**7-C-23-HZ**  
**APPLICATION FOR CERTIFICATE OF APPROPRIATENESS**

**1202 Luttrell St. 37917**  
**Fourth and Gill H**

Level II Major Repair or Replacement

North 2 (3)

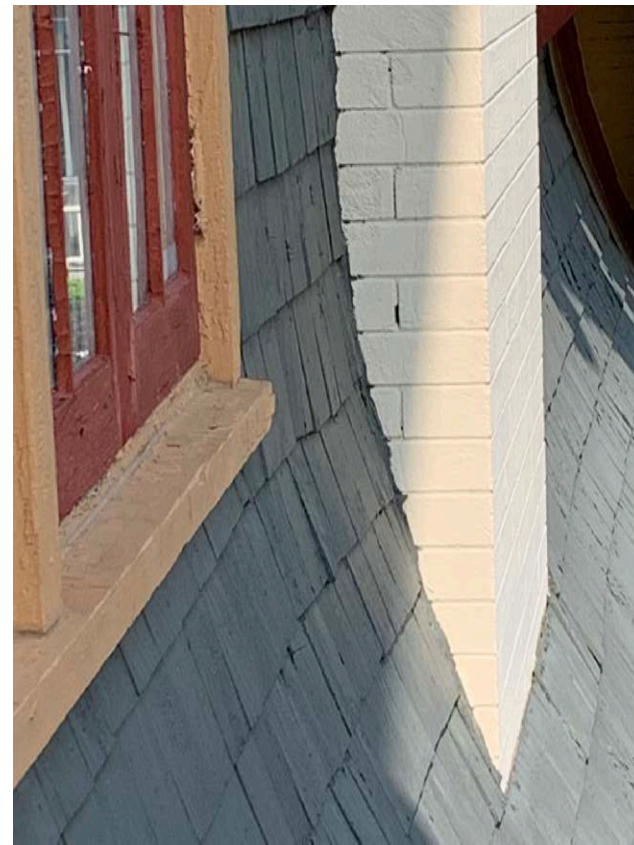
- #1. Double casement. Sill has rotted under metal flashing. Header is cracked where lock is, indications of rot also. Many of the TDL panes have been replaced with much newer glass.
- #2. DH, balance cords have been cut. Top light screwed into place as the keeper rail wood is rotted so screws will hold the lock keeper. Lower handle rail shows significant exterior rot. Interior grids are very soft, indicating rot not just on the inside but the exterior as well.
- #3. Double casement, office. Bottom of the sash and sill are rotting, operating hardware missing rendering window inoperable. Interior grid rot appearing on TDL grids. Several pieces of glass have been replaced.
